GULF STATES UTILITIES COMPANY

May 15, 1985
RBG-21,018
File Nos. G9.5, G9.33.4,
G9.19.2

River Bend Station - Unit 1
Docket No. 50-458

The attached response provides additional information requested in a letter dated August 30, 1984 from Mr. A. Schwencer to Mr. W. J. Cahill, Jr. concerning the River Bend Station Safety Parameter Display System (SPDS). The SPDS hardware is currently installed. The SPDS is scheduled to be fully functional (i.e., tested, procedures approved and training completed) by February 1986.

FIGURE 1

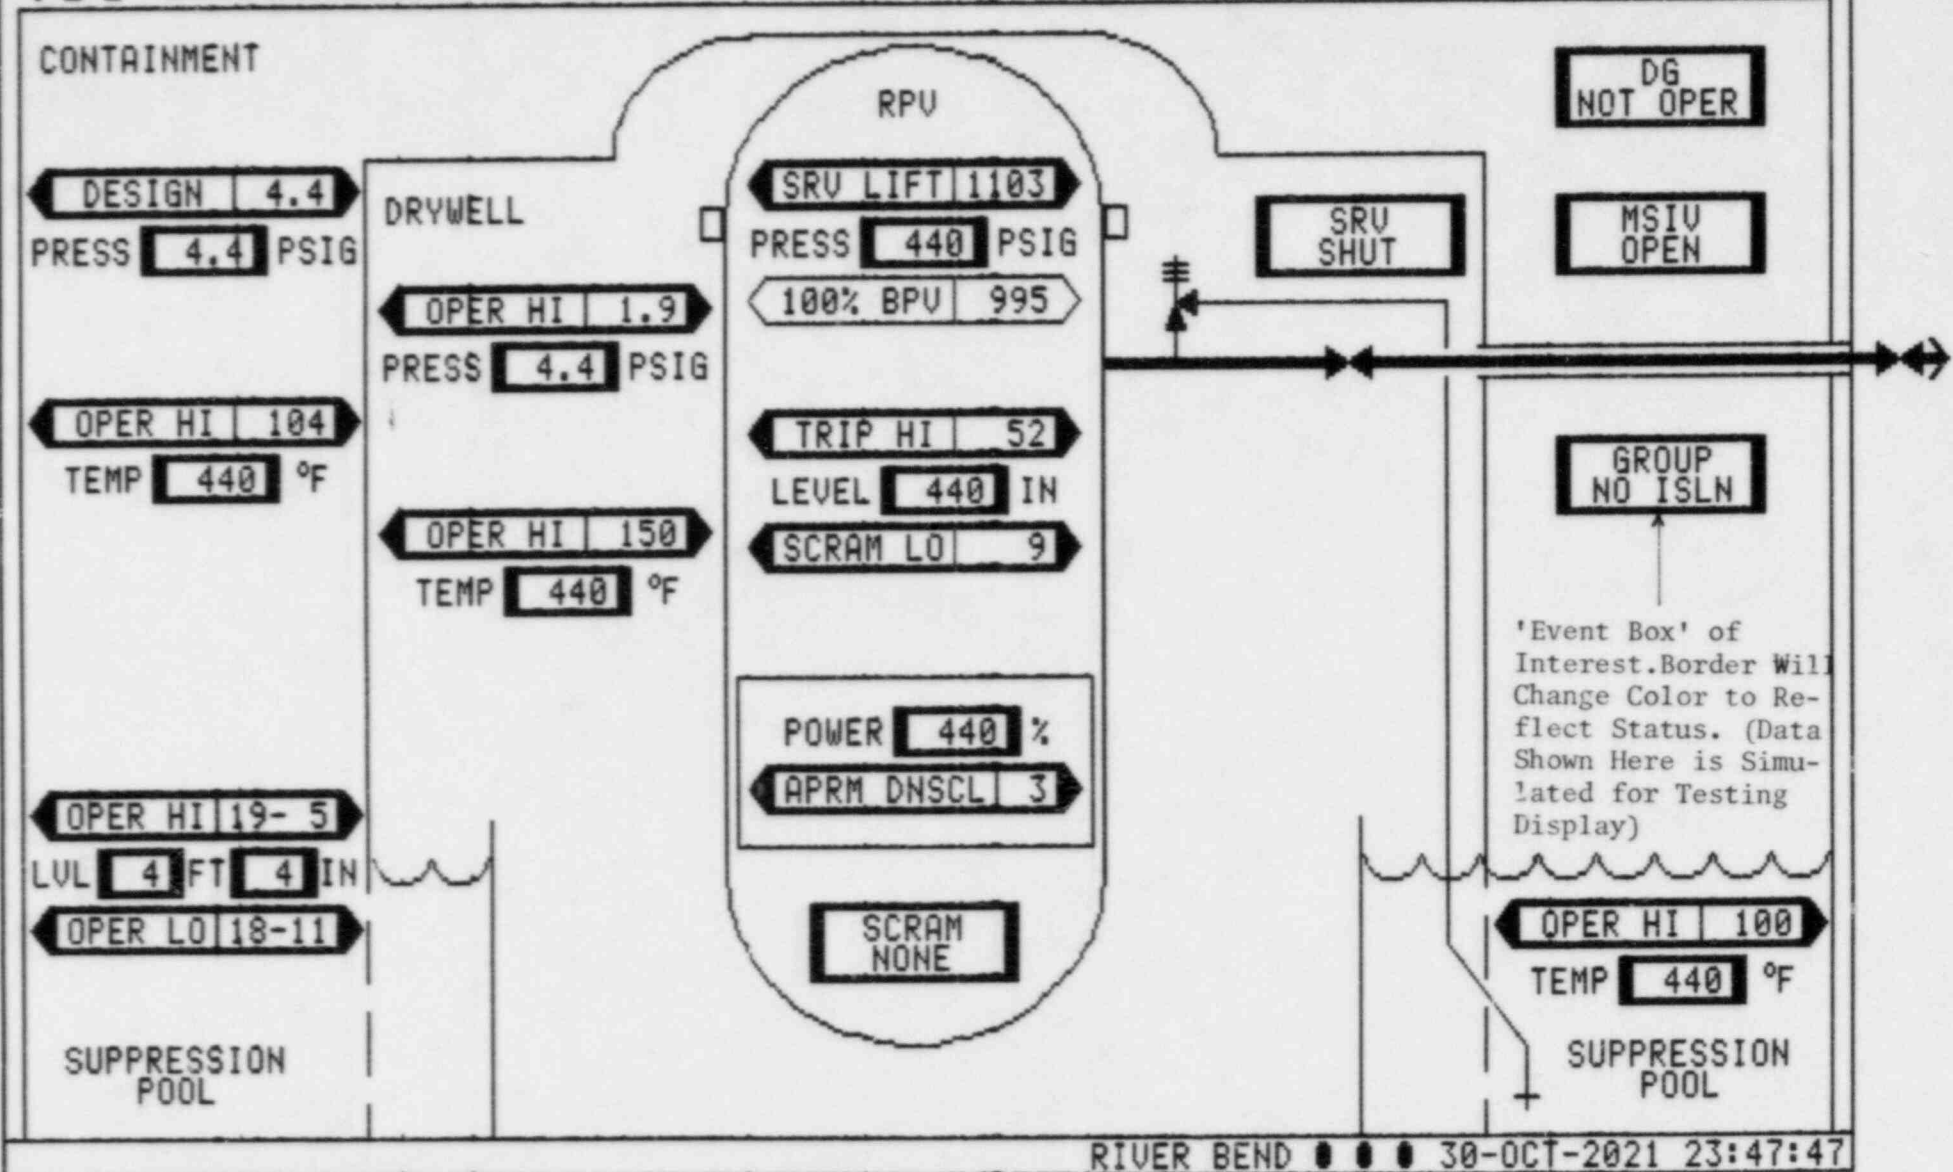
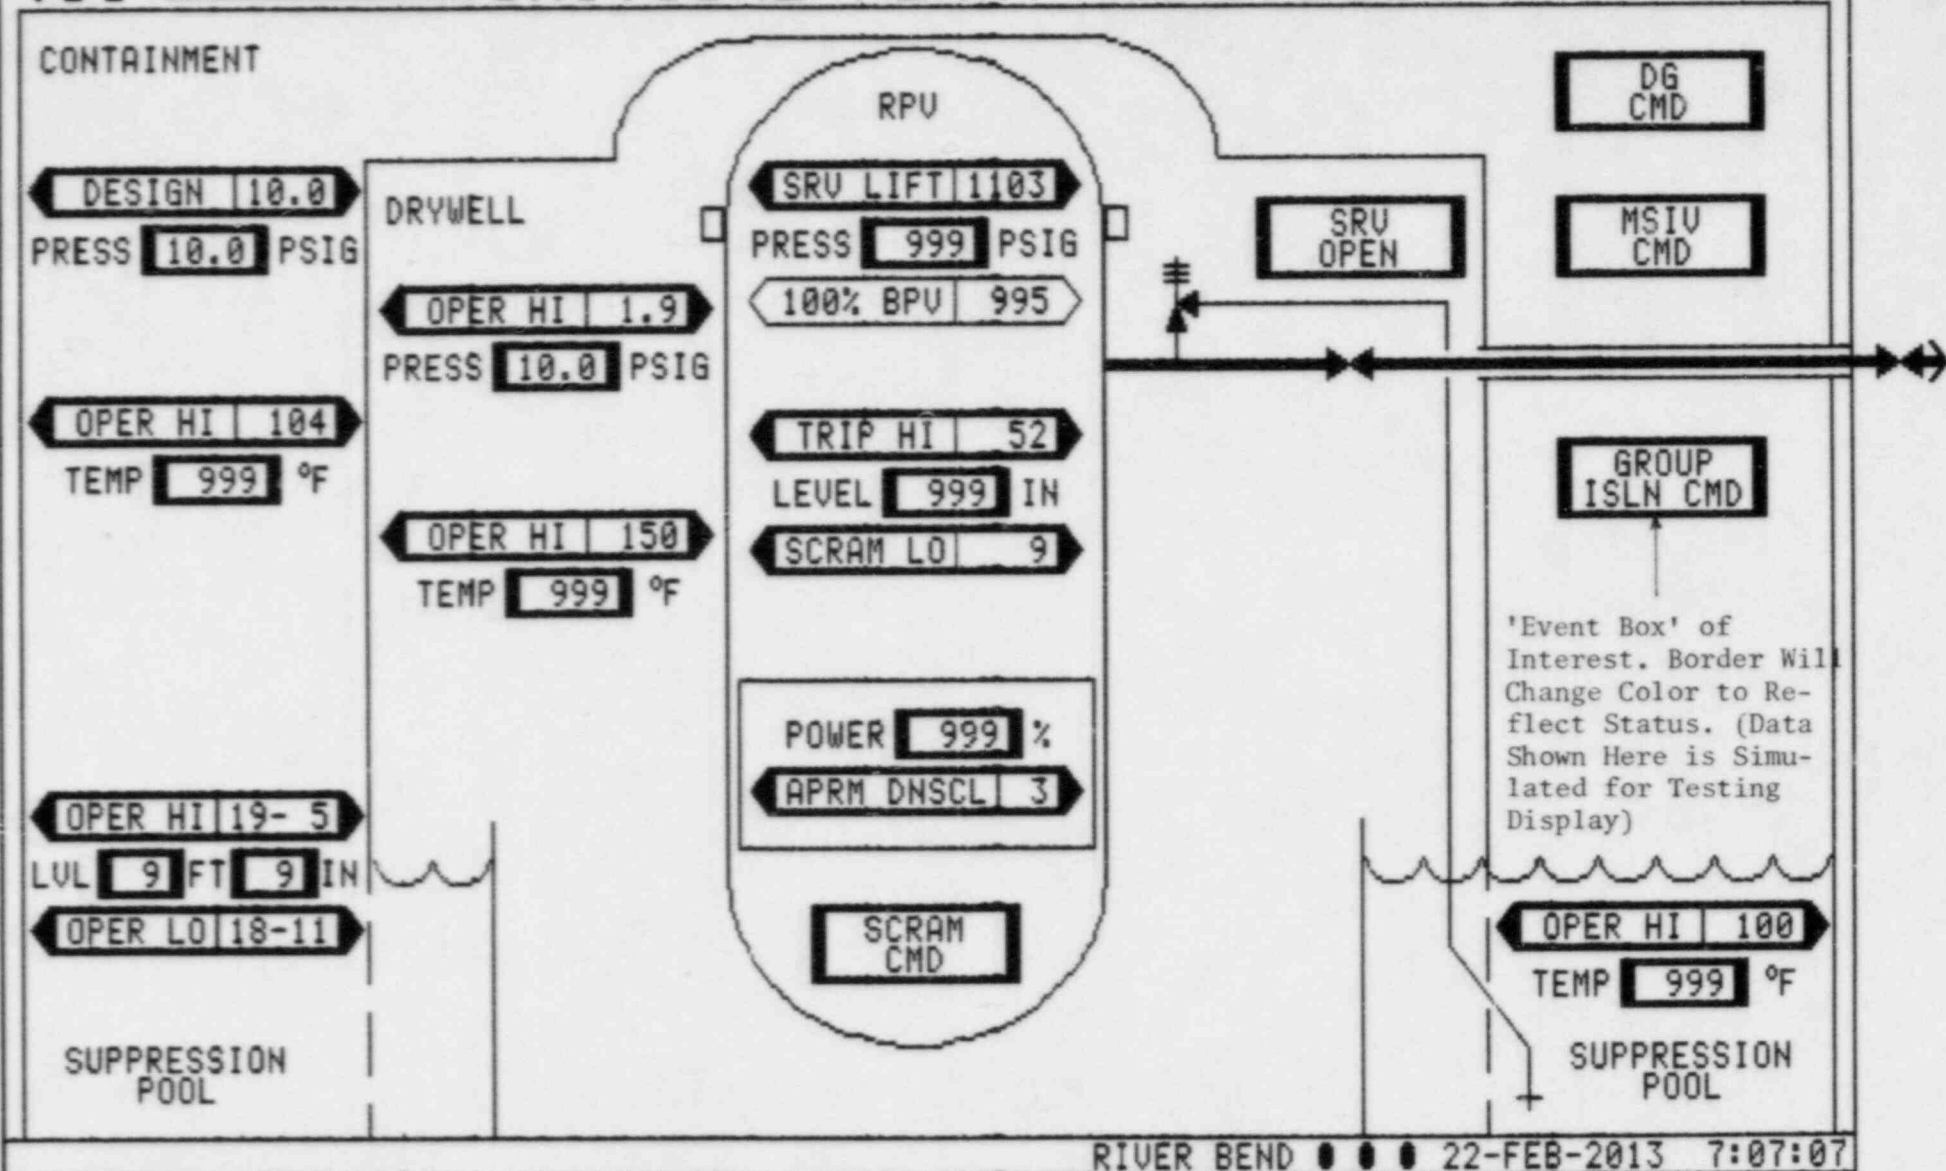
- d. How is the status of containment isolation identified on the SPDS?
- e. Provide a Listing or Table relating the SPDS safety parameters to the five Critical Safety Functions identified in 4.1(f) of Supplement 1 to NUREG-0737 (Generic Letter No. 82-33).

- d. The status of containment isolation will be displayed by the ERIS SPDS in two (2) ways. The first is an 'event box' on selected displays that shows group isolation status (see attached Figures 1, 2 and 3). This box will indicate "NO ISLN" (no isolation), "ISLN CMD" (isolation command), or "ISOL" (isolation). The text within the event box always appears white. The border of the event box changes color to reflect current status. During normal operation, the border will be blue and the text will read "NO ISLN". When an isolation command is sensed, the text will read "ISLN CMD", and the box border will turn yellow. If a valve(s) does not isolate, the border of the box will turn red. The border will also turn red if a valve(s) fails to isolate by a pre-determined time. The pre-determined time constant represents the upper limit of the expected travel times for valves after an isolation signal. If isolation is successful, the border of the event box will turn green and the text will read "ISOL". The border will also change from red to green, and the text to "ISOL", after a slow valve has achieved it's isolation position. The valves that are designed to respond to an isolation command are used as input to the algorithm that drives this event box, so that the failure of any valve to isolate will alert the operators to a problem.
